L-PI-09-071
10 CFR 72.56

Prairie Island Independent Spent Fuel Storage Installation
Docket No. 72-10
Materials License No. SNM-2506

Supplement to License Amendment Request (LAR) to Modify TN-40 Cask Design
(Designated as TN-40HT) (TAC No. L24203)

ENCLOSURE 3

FIGURE A4.2-14
TN40HT FUEL CLADDING FINITE ELEMENT MODEL

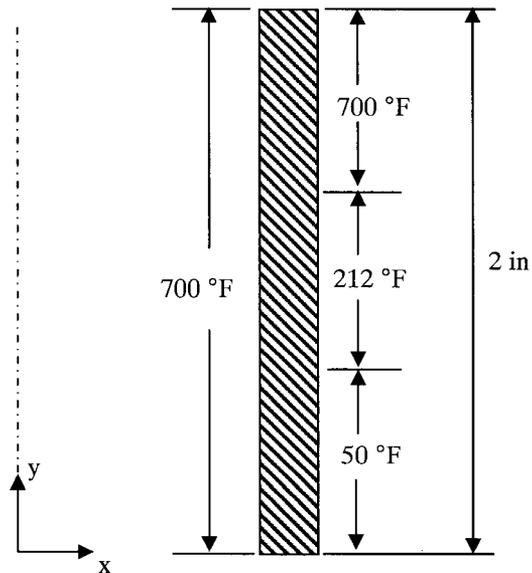
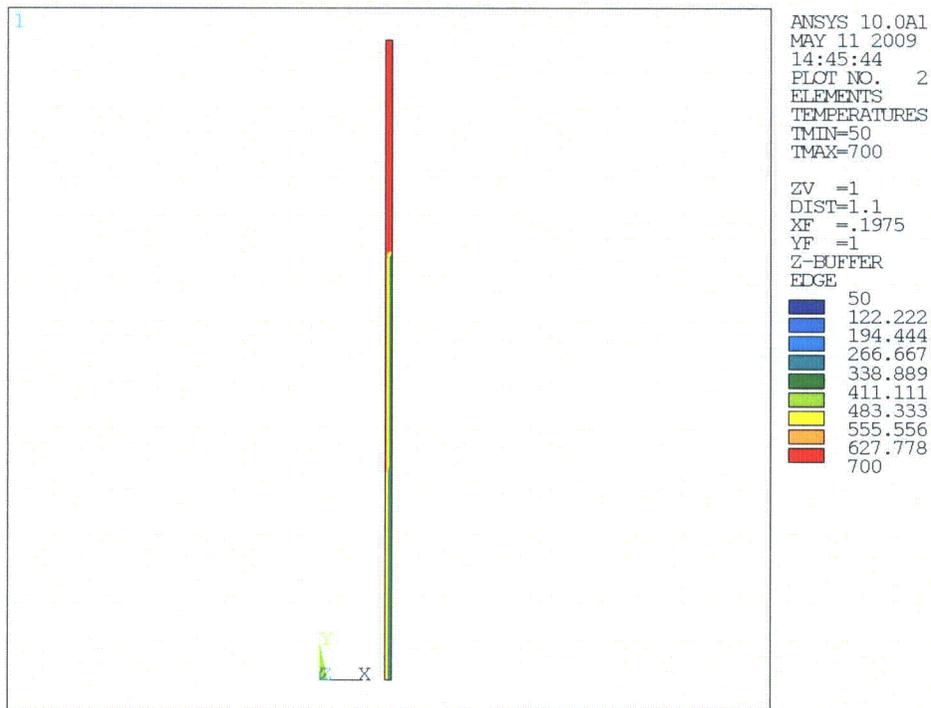
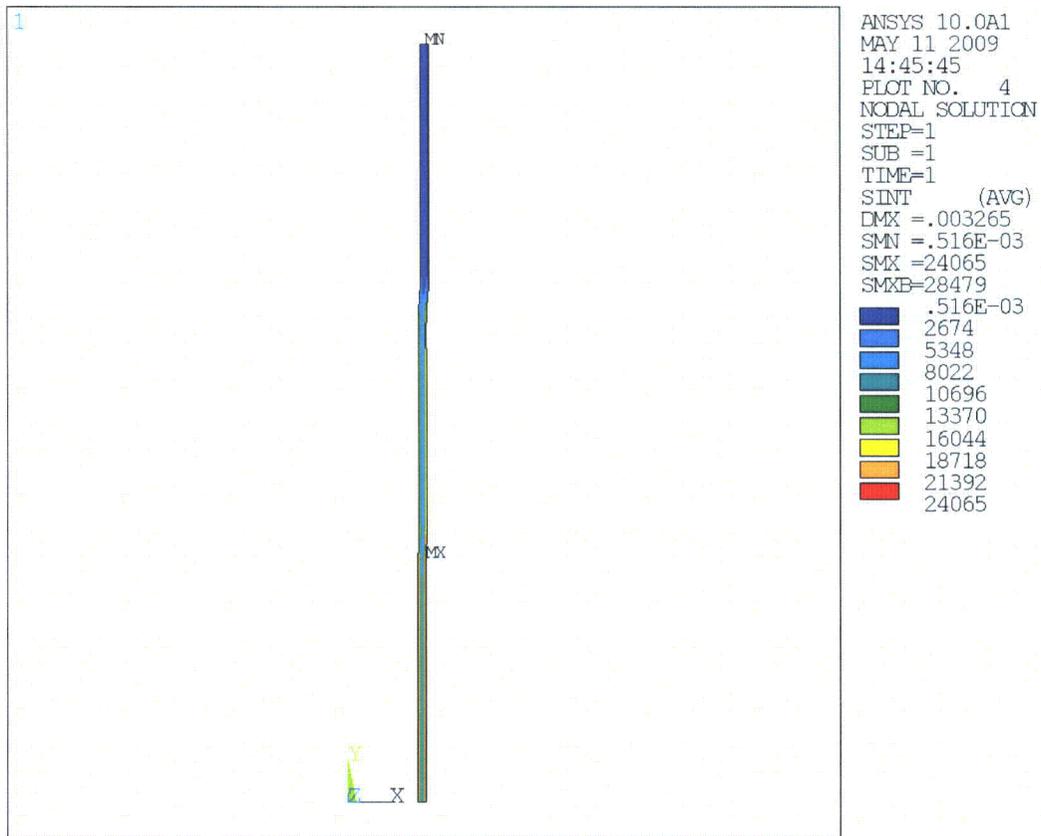
Analyses of the thermal gradient and resulting stresses during reflooding will be added in new SAR Section A4.2.3.9.

- A conservative high maximum fuel cladding temperature of 700 °F and quench water temperature of 50 °F are used.
- The fuel rod is assumed to be simply supported at both ends.
- The outer surface temperatures of the fuel cladding are conservatively assumed as shown in Figure A4.2-13. 50 °F (water), 212 °F (steam), and 700 °F (cladding) temperature occurs at three equal heights.
- The fuel cladding thickness and cladding outside diameter are reduced by 0.00270 inch to account for oxidation.

The finite element model is shown in Figure A4.2-14. ANSYS (Reference

Steady state thermal analysis was conducted using the surface nodal temperatures as shown in Figure A4.2-13. The inside surface nodal temperatures are all assumed to be 700 °F, and the outside surface temperatures to conservatively represent the quench water temperature. The temperature distribution resulting from this analysis is shown in Figure A4.2-15.

A thermal stress analysis using the same model was conducted using the nodal temperatures obtained from the thermal analysis. The resulting nodal stress intensity distribution is shown in Figure A4.2-16. The maximum nodal stress intensity in the fuel cladding is 24.0 ksi. This stress is less than the yield strength of Zircaloy, which is 92 ksi at 750 °F.

Figure M19-1 UO₂ Thermal Conductivity

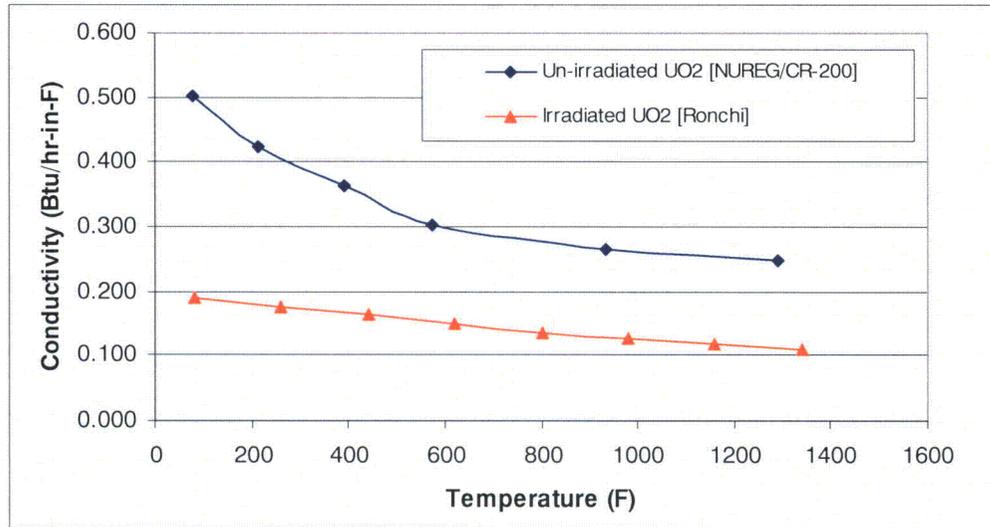
Provide references for the thermal characteristics of the neutron shield resins given on page 6 of SAR, Table A3.3-8.

Effects of irradiation on the thermal conductivity of UO₂ were studied by Amaya et al. (Reference M19-1) and Ronchi et al. (Reference M19-2). Based on the study by Ronchi et al., the thermal conductivity of irradiated UO₂ with ~62 GWd/t and irradiation temperature $T_{irr} \geq 1300K$ (average T_{irr} for fuel pellet during irradiation according to Amaya et al.) can drop significantly (more than 50%) compared to un-irradiated UO₂.

The thermal conductivity values of UO₂ used to calculate the effective fuel conductivity are listed in SAR Section A3.3.2.2.3.6.2.1 and are for un-irradiated pellets. Figure M19-1 below compares these values to those obtained from the study by Ronchi et al. The comparison shows that in the temperature range of interest (600°F to 750°F) the SAR conductivity values are higher by approximately a factor of two compared to values obtained from Ronchi et al.

The use of irradiated UO₂ conductivity would decrease the calculated effective fuel conductivity in the transverse direction. (Note that as discussed in SAR Section A3.3.2.2.3.6.3.2, axial effective fuel conductivity is calculated based on the fuel cladding material only and does not include the UO₂ fuel pellet thermal conductivity. Therefore, the axial effective conductivity of the fuel assembly is not impacted.) However, the transverse effective conductivities in the SAR were calculated using unirradiated UO₂ and the results are summarized in SAR Table A3.3-9.

Figure A4.3-2 Bottom Shield Plate, Cross Section Locations

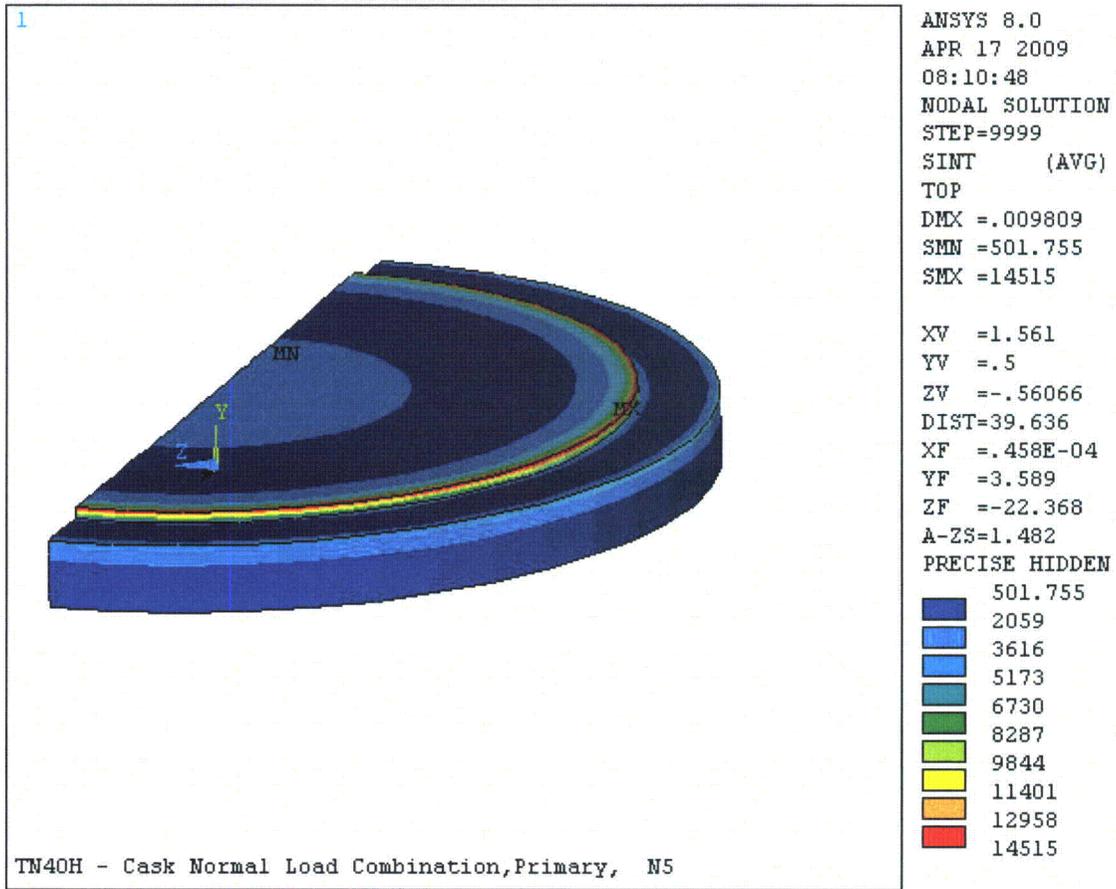
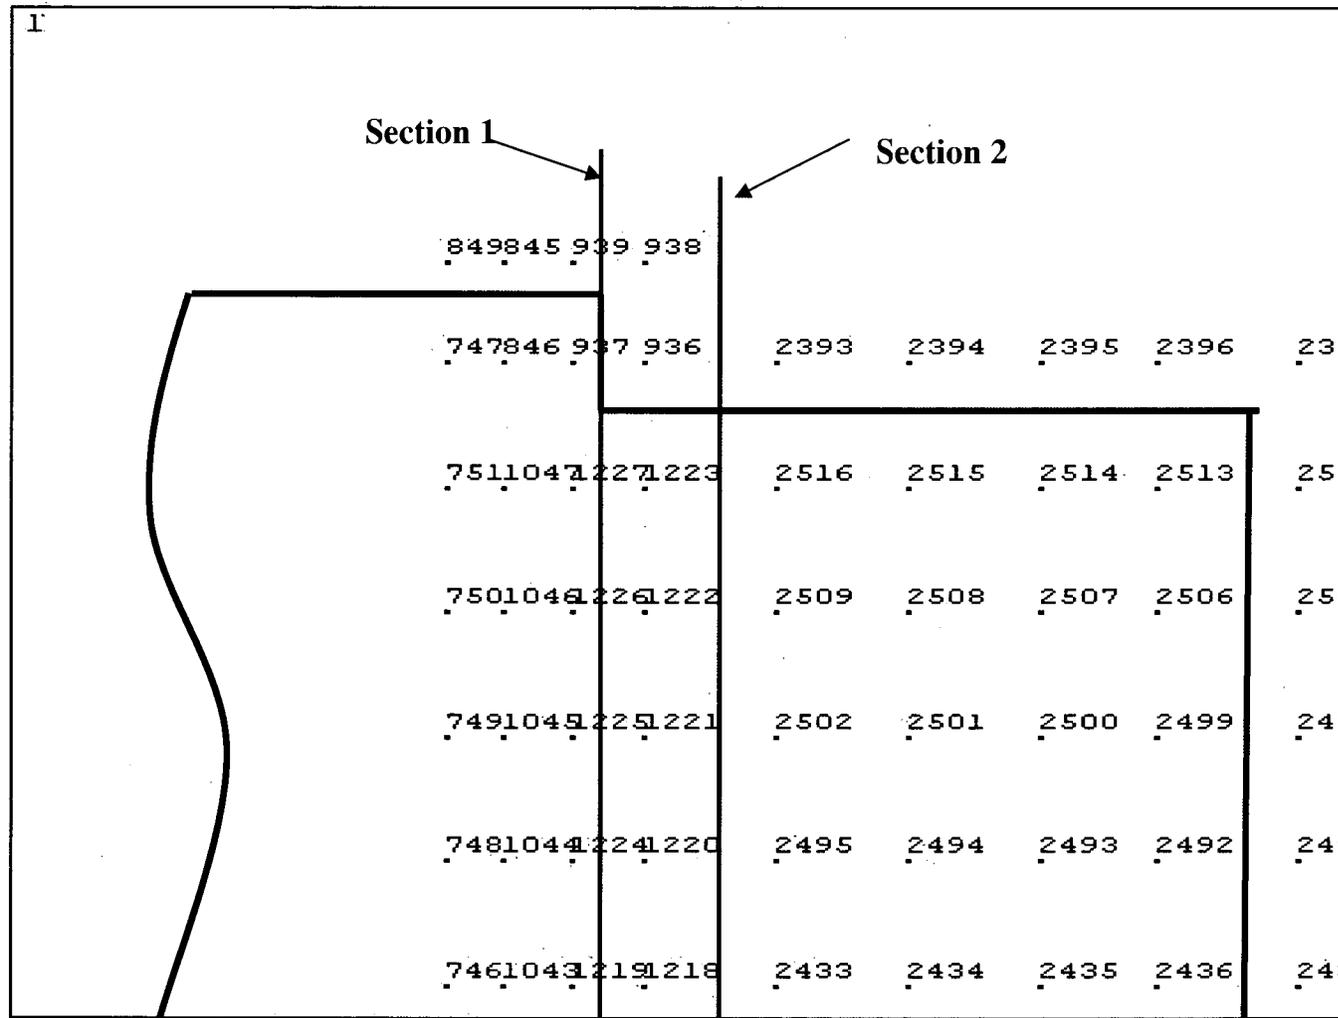
With respect to load combination Case N5, the process of nodal stress components combination at Nodes 938 and 1218 and intervening Nodes 936, 1223, 1222, 1221 & 1220 (see Figure A4.3-2, cross section 1) and stress intensity computations are properly implemented by ANSYS postprocessor by following the procedure given in ASME Boiler and Pressure Vessel Code, Section III, Subsection NB, Para NB-3215. According to ANSYS postprocessor procedure, stress components S_x , S_y and S_z for normal stresses and S_{xy} , S_{yz} and S_{zx} for shear stresses (in global or prescribed coordinate system) of individual loads are algebraically combined for the load combination case at all the nodes defining the cross section. Each combined stress component is then linearized to get membrane, bending, membrane plus bending and peak stress categories at the beginning, mid-length and the end of the cross section. Principal stresses S_1 , S_2 and S_3 are computed using the membrane, bending, membrane plus bending and peak component stresses. Stress differences S_{12} , S_{23} and S_{32} are calculated using these principal stresses and stress intensity S is the largest absolute value of S_{12} , S_{23} and S_{31} for membrane, membrane plus bending and peak stresses.

The listed primary stress intensities P_m and $PI + Pb$ of 1.98 ksi and 5.67 ksi, respectively, at the cross section defined by Nodes 938 and 1218, are much smaller than the maximum nodal stress intensity of 14.52 ksi at Node 938. The reason being that a high stress intensity of 14.52 ksi occurs locally where the gamma shield cylinder contacts the corner of the Bottom Shield Plate (see Figure A4.3-1). In the remaining large portion of the cross section, the stresses are small. The stress linearizing details at this cross section (Figure A4.3-2, cross section 1), using the ANSYS processor, are given in Table A4.3-1. It can be seen that although membrane and membrane plus bending stress intensities are small at the top (Node 938) and bottom (Node 1218) of the cross section, a high peak

For further verification, an adjoining cross section defined by Nodes 2393 and 2433 (and intervening nodes) is selected for linearizing (see Figure A4.3-2, cross section 2). The maximum nodal stress intensity at this section is 2.42 ksi. Local stresses at this cross section are expected to be negligible. The linearized stress intensities at this cross section are listed in Table A4.3-2. It is seen that the maximum membrane plus bending and peak stress intensities are calculated as 2.16 ksi and 0.68 ksi respectively and the sum of membrane plus bending and peak stress intensities is quite close to the maximum nodal stress intensity.

It is seen from the above that the ANSYS stress linearization postprocessor has properly implemented the load combination cases for the cask body stress evaluation.

**FIGURE A4B.1-2
TN-40HT BASKET LOADING ORIENTATION DEFINITIONS**

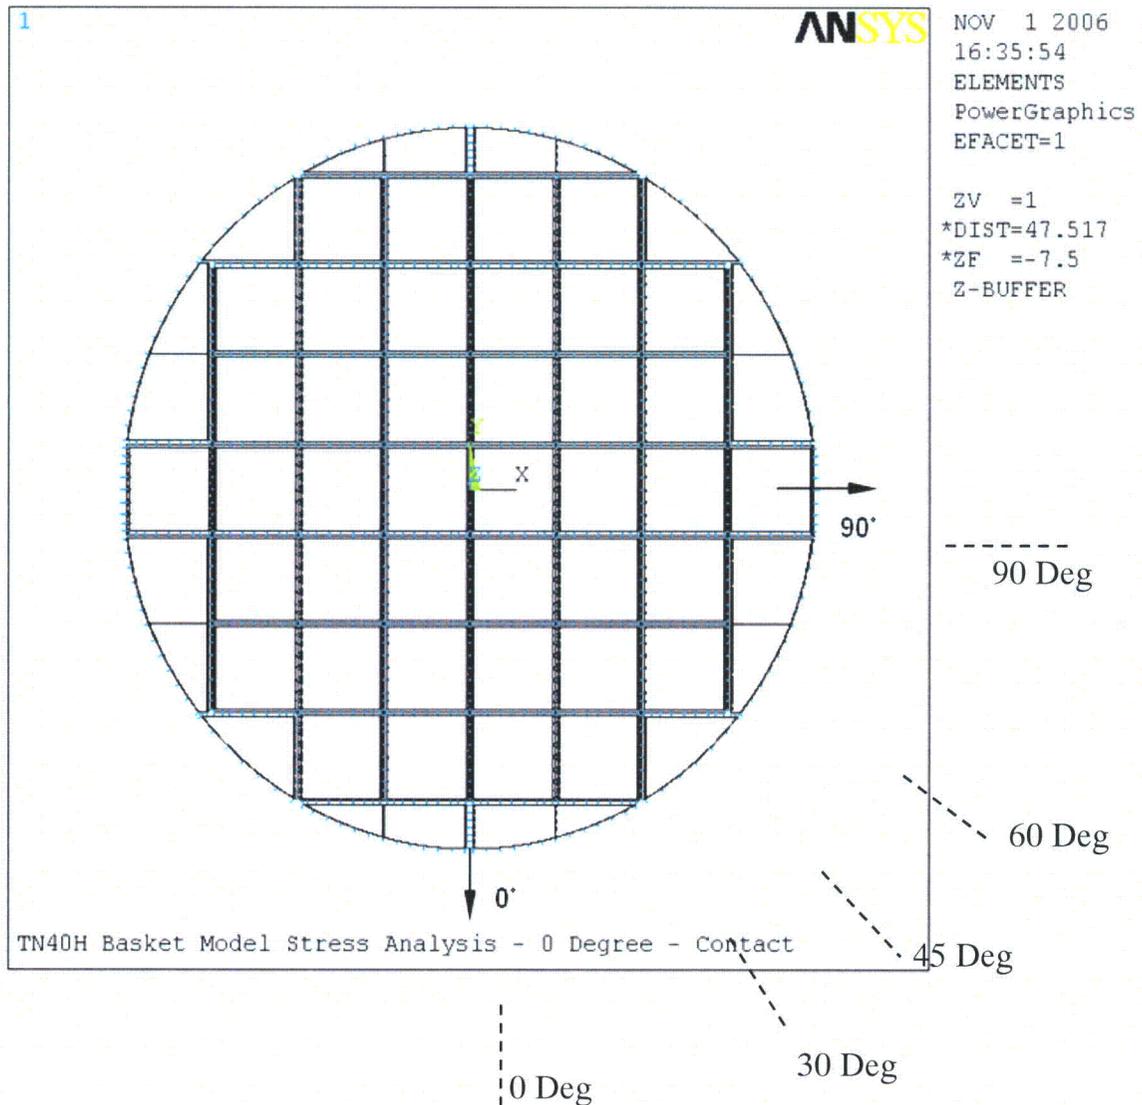
Revise Figures A4B.1-2, A4B.1-3 and add additional sketches to provide sufficiently legible details to depict element types, discretization schemes, and interface as well as boundary conditions, as appropriate, for the structural analysis of the basket subject to lateral loads.

The title of Figure A4B.1-2 will be modified to clarify that it shows the loading orientations only. Figure A4B.1-3 will be modified to the new figure shown below. Figure A4B.1-21 and A4B.1-22 below will be added to clearly depict the element types, discretization schemes, interface, and boundary conditions. In addition to modifying the figures, the text in Section A4B1.5 will be modified to reflect the appropriate figure numbers and the last sentence in the third paragraph in Section A4B1.5.2.1 will be replaced with the following:

**FIGURE A4A.10-1
OVERVIEW OF FINITE ELEMENT MODEL**

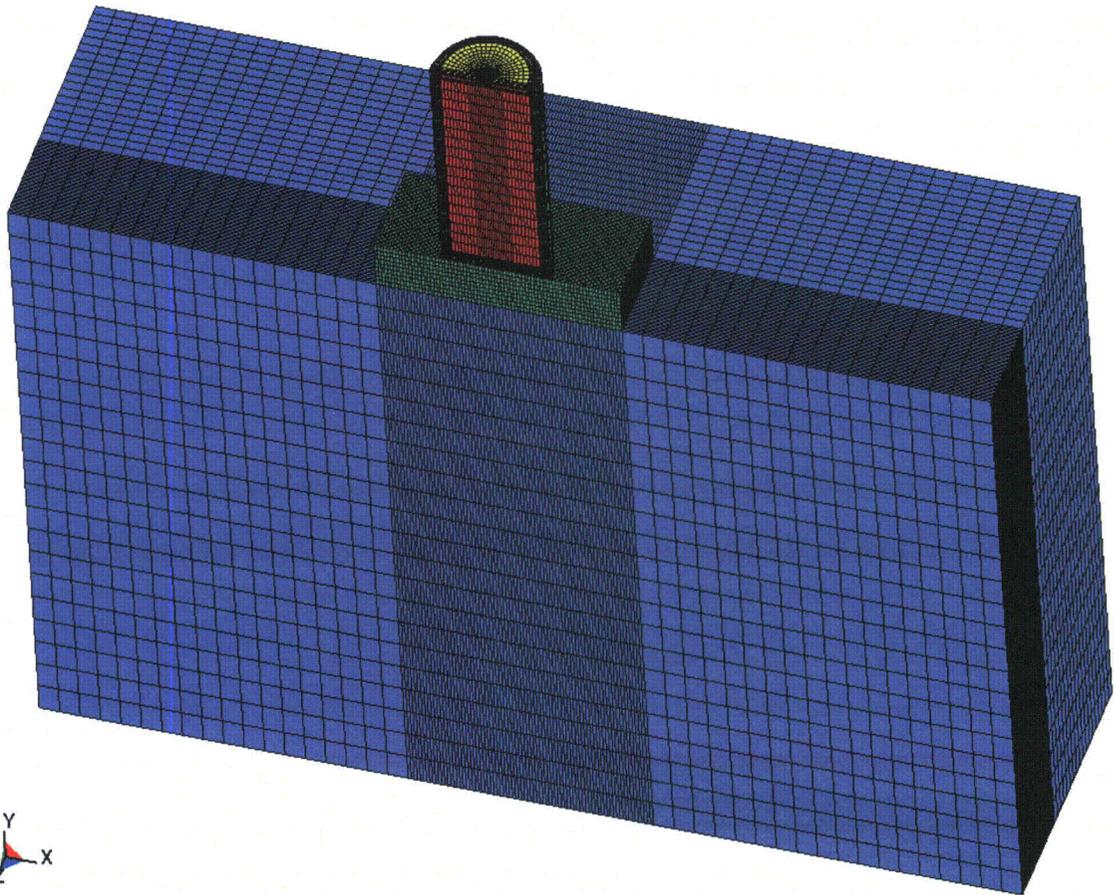
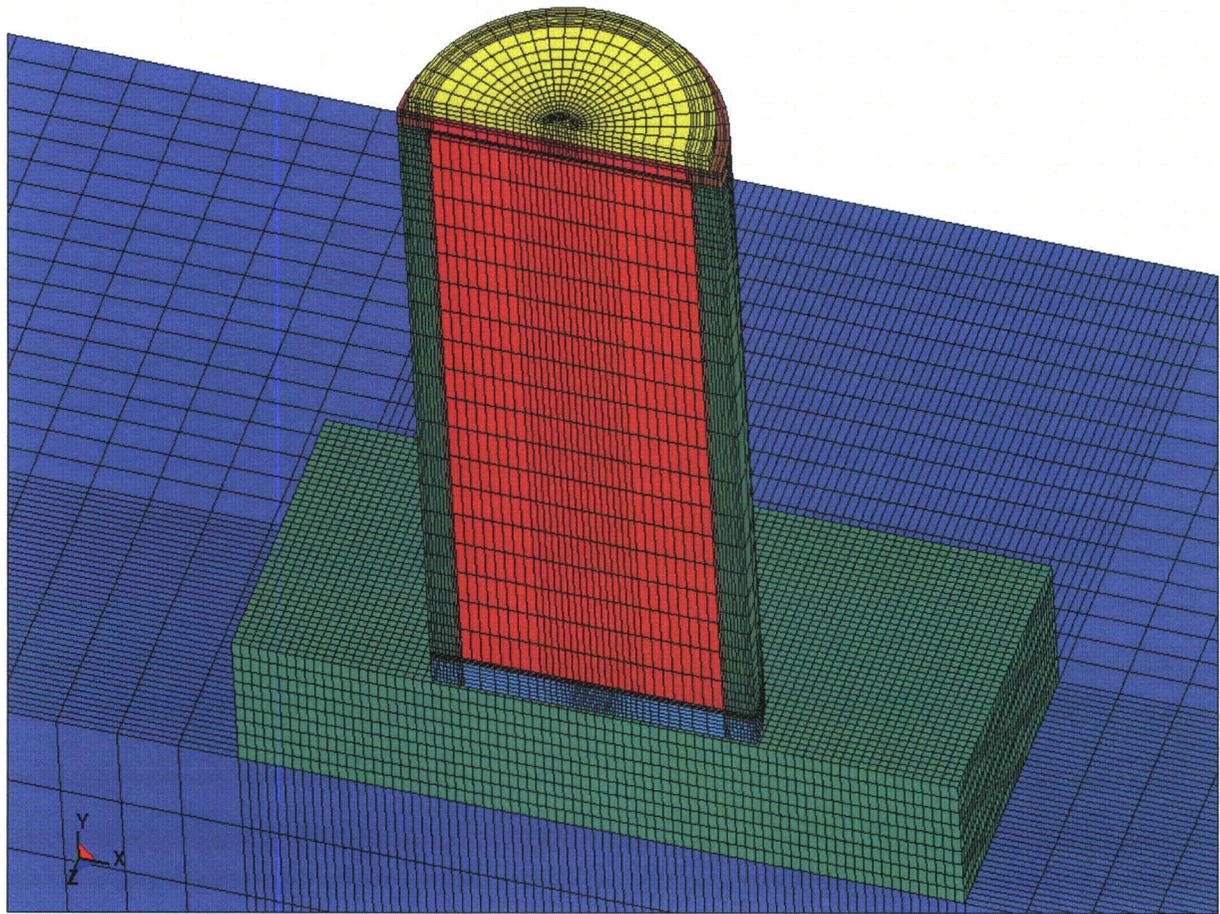
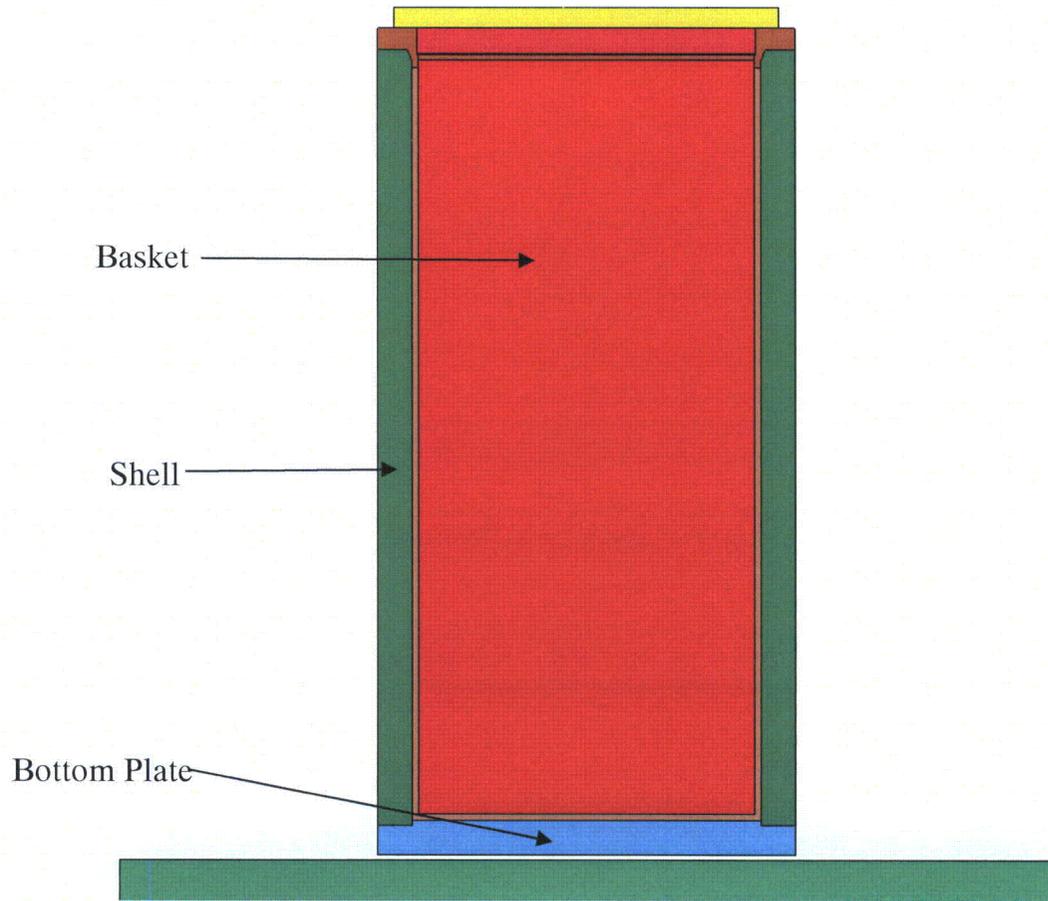
Transient dynamic analysis of the cask for the 18-inch end-drop using LS-DYNA was performed to determine decelerations and will be added to new SAR Section A4A.10. The calculation to determine decelerations using EPRI NP-7551 will be removed from Section A8.2.8.2.1.

The geometry of the cask finite element model including the cask internals, concrete and base soil is shown in Figure A4A.10-1 and Figure A4A.10-2.

The resulting rigid body acceleration time histories were computed by LS-DYNA. The rigid body accelerations were computed for the bottom plate, circumferential shell, and basket representation. The parts can be seen in Figure A4A.10-3.
